TRANS/WP.29/GRSG/2005/20  
25 July 2005

World Forum for Harmonization of Vehicle Regulations (WP.29)

PROPOSAL FOR DRAFT 02 SERIES OF AMENDMENTS TO REGULATION No. 107

(M2 and M3 vehicles)

"Figure 1 1/

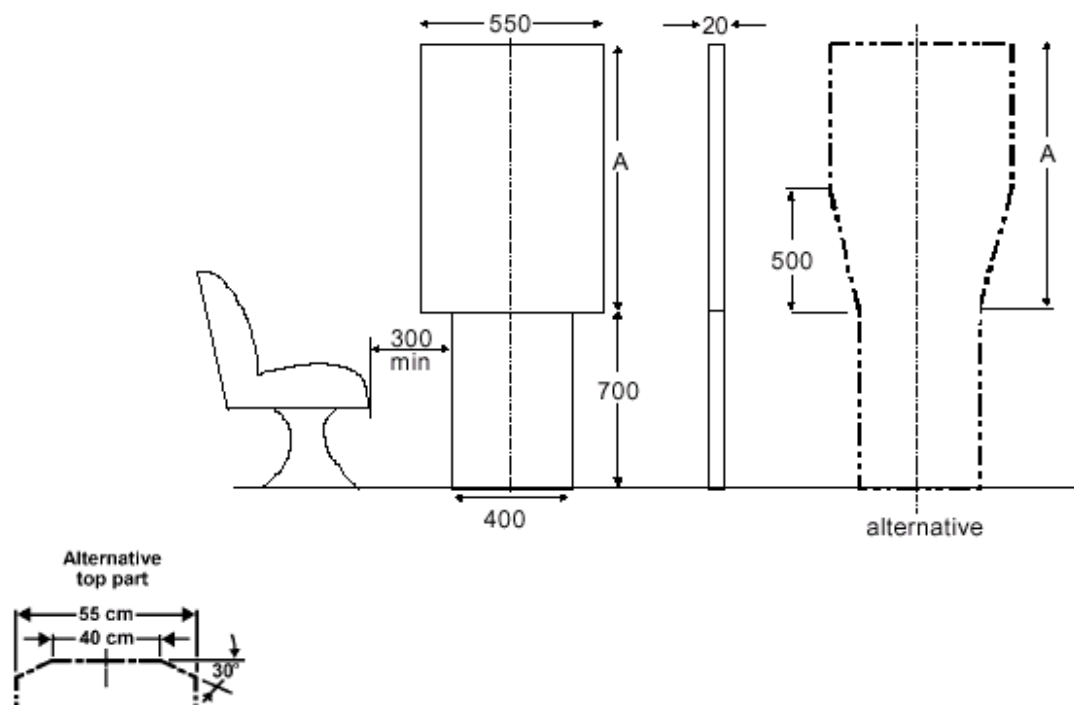
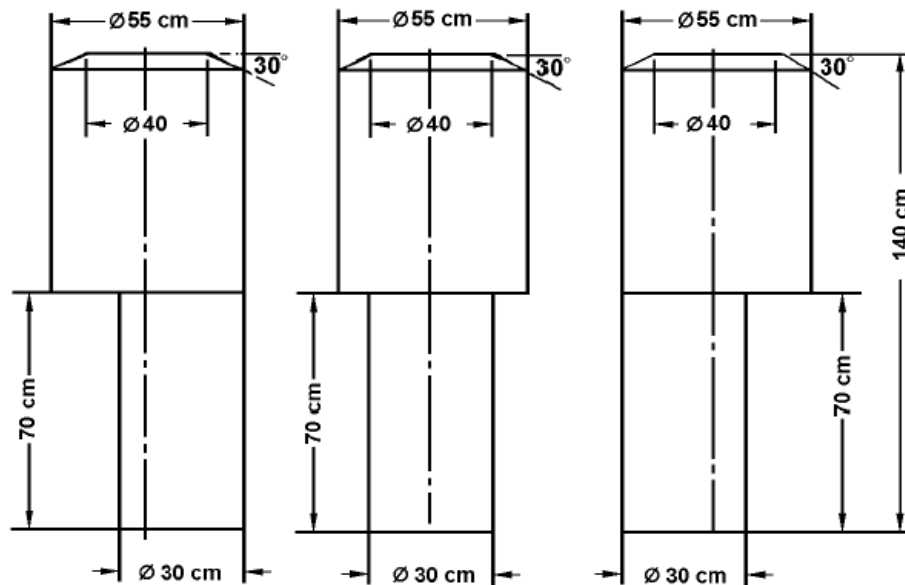
Figure 1, amend to read:

1/ "Alternative top part" diagram should be revised before publication to refer to "550 mm" and "400 mm" as appropriate."

Classes I, II and III: A = 1100 mm

Classes A and B: A = 950 mm

Number of passengers	≤ 22 (1)		> 22		
	A	B	I	II	III
Classes					
Dimension A (mm)	950	700	1100	950	850
Total height of dual panel	1650	1400	1800	1650	1550

"Figure 6  
GANGWAYS  
(see Annex 3, paragraph 7.7.5.)

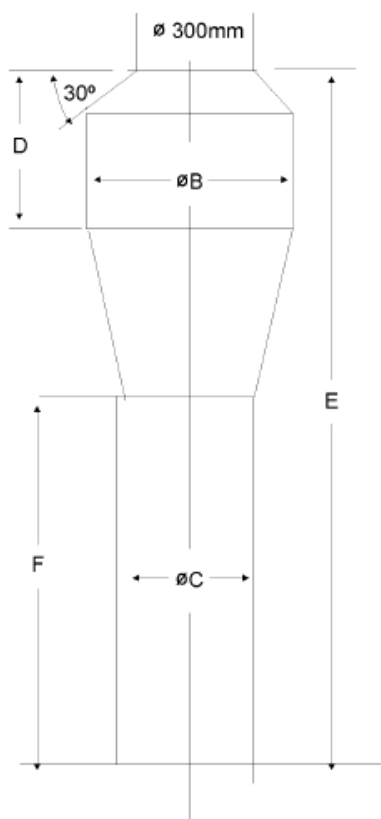
Figure 6, amend to read:

Single deck						
Class		B (mm)	C (mm)	D (mm)	E (mm)	F (mm)
A		550	350	500 (4/)	1900 (4/)	900
B		450	300	300	1500	900
I		550	450 (3/)	500 (4/)	1900 (4/)	900
II		550	350	500 (4/)	1900 (4/)	900
III		450	300 (2/)	500 (4/)	1900 (4/)	900
Double deck						
I	LD	550	450 (3/)	500	1800 (1/)	1020 (1/)
	UD	550	450(3/)	500	1680	900
II	LD	550	350	500	1800 (1/)	1020 (1/)
	UD	550	350	500	1680	900
III	LD	450	300 (2/)	500	1800 (1/)	1 020 (1/)
	UD	450	300 (2/)	500	1800	900

- (1/) The overall height of the gauging device may be reduced (by reducing the height of the lower cylinder):
- (a) from 1800 mm to 1680 mm in any part of the gangway of the lower deck to the rear of a transverse vertical plane situated 1500 mm forward to the centre of the rear axle (foremost rear axle in the case of vehicles with more than one rear axle),

- (2/) 220mm in the case of laterally movable seats (see paragraph 7.7.5.3).
- (3/) The diameter of the lower cylinder may be reduced from 450 mm to 400 mm in any part of the gangway to the rear of the most forward of the following two planes:

"Figure 8

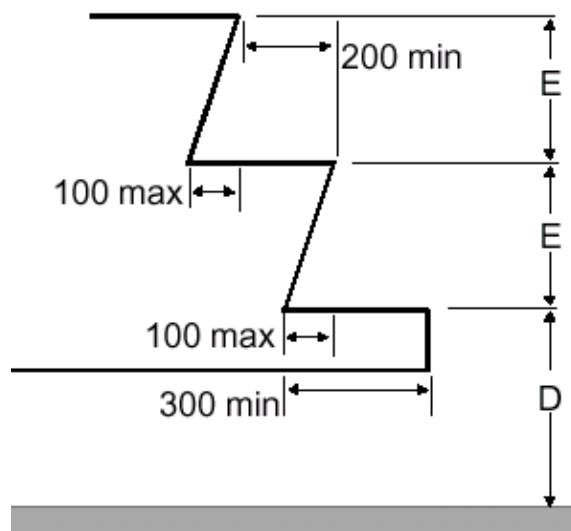
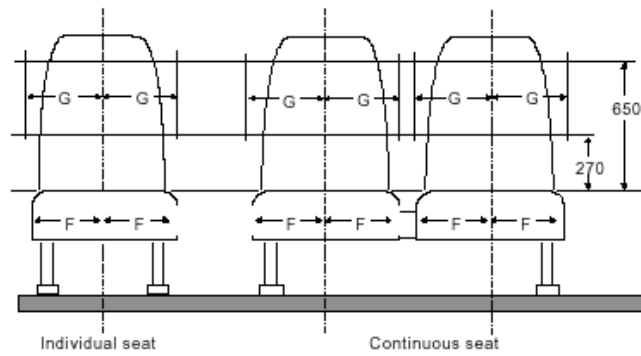
Figure 8, amend to read:

Classes		I & A	II, III and B
First step from ground 'D'	Max. height (mm)	340 (1)	380 (1)(2)(5)
	Min. depth (mm)	300 (*)	
Other steps 'E'	Max. height (mm)	250 (3)	350 (4)
	Min. height (mm)	120	
	Min. depth (mm)	200

Note: 1. At a double doorway the steps in each half of the access passage shall be treated separately.  
2. E need not be the same for each step."

Figure 9A

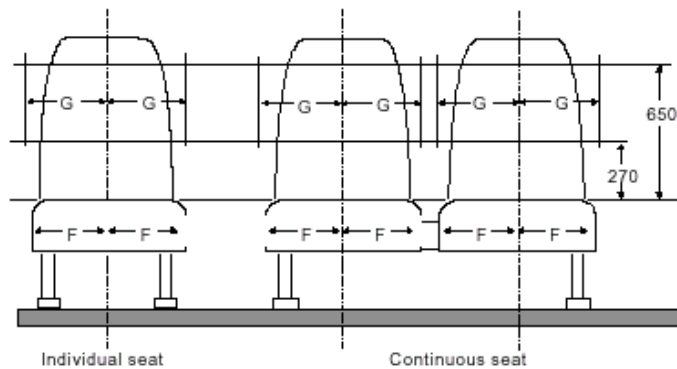
Figures 9 and 9A, amend to read:

G (mm) min	
F (mm) min	Continuous seats	Individual seats
200	200	200

"Figure 15

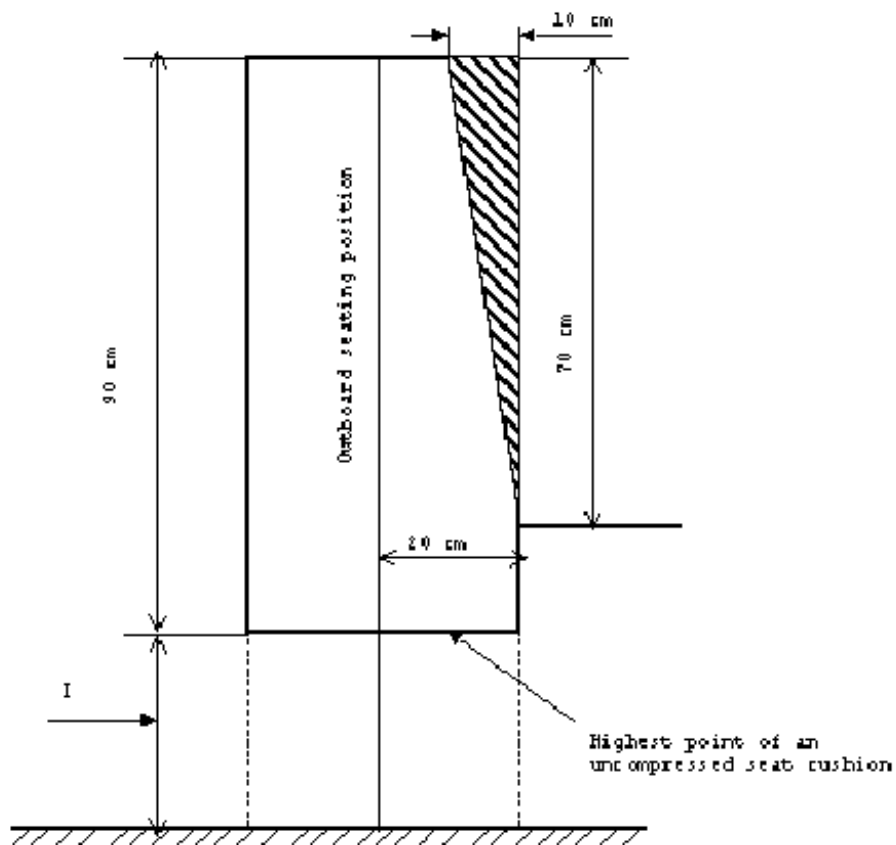
Figure 15, amend to read:

[Editorial note: In final version, dimensions on diagram should be converted to mm]"

I (mm)
400 to 500
(for classes A, B, I and II min 350 mm at wheel arches and engine compartment(s))

"Figure 20

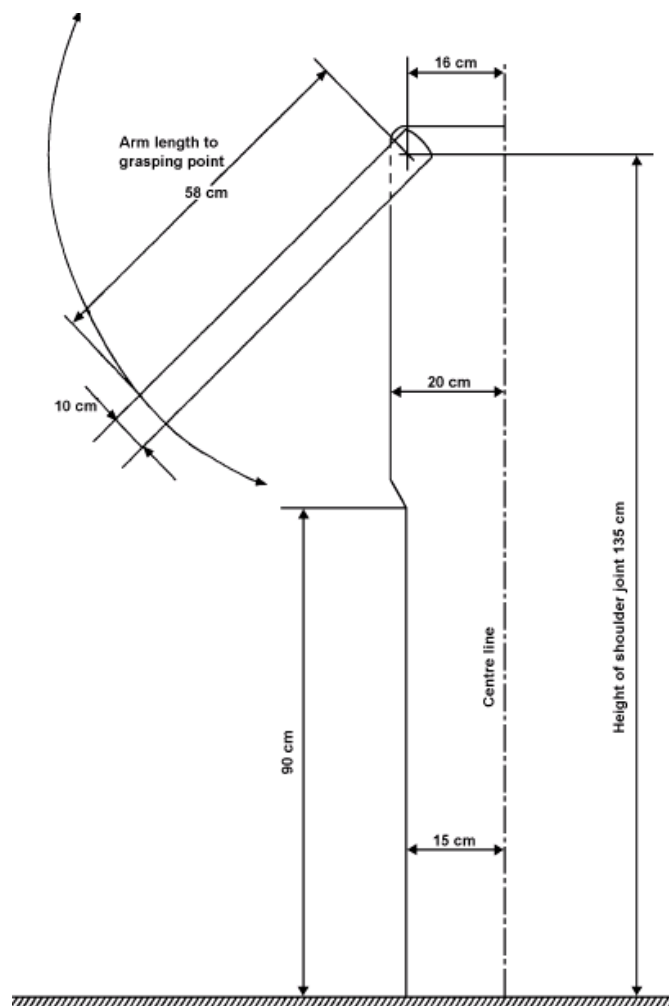
Figure 20, amend to read:

Thickness: 2cm."

Figure 25

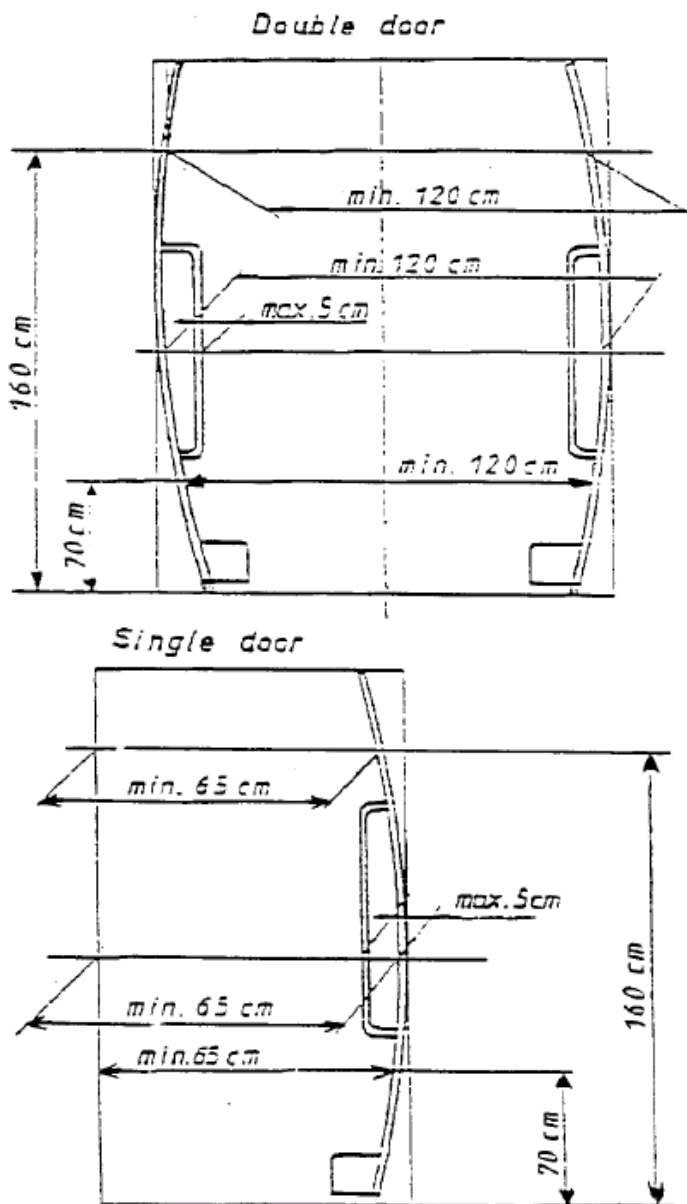
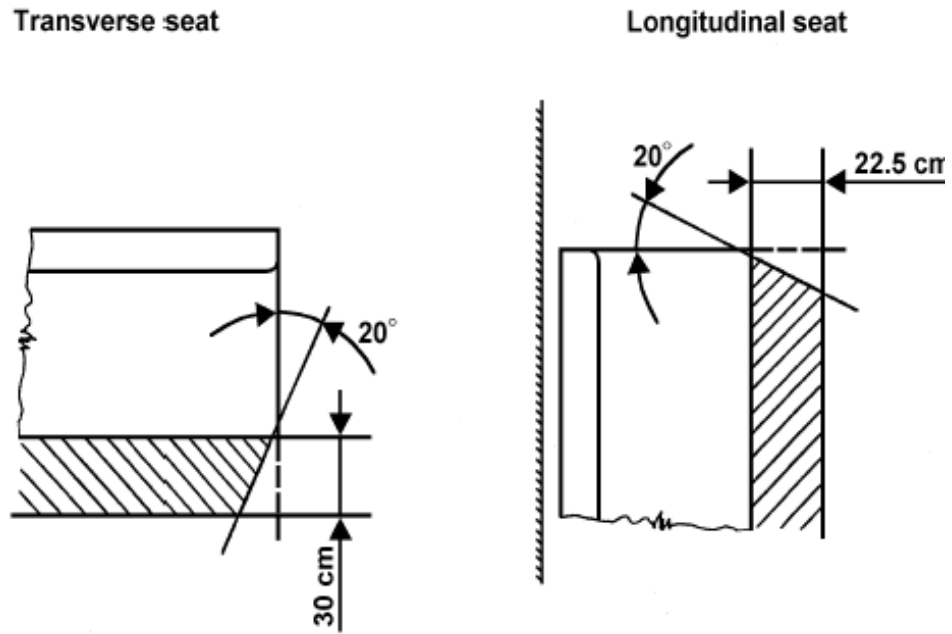
Insert new figures 24 to 26, to read:

"7.7.1.6. The free passage clearance for this figure shall not include any space extending to 300 mm in front of any uncompressed seat cushion of a forward or rearward facing seat, or 225 mm in the case of seats fitted at wheel arches, and to the height of the top of the seat cushion (see Annex 4, figure 25)."
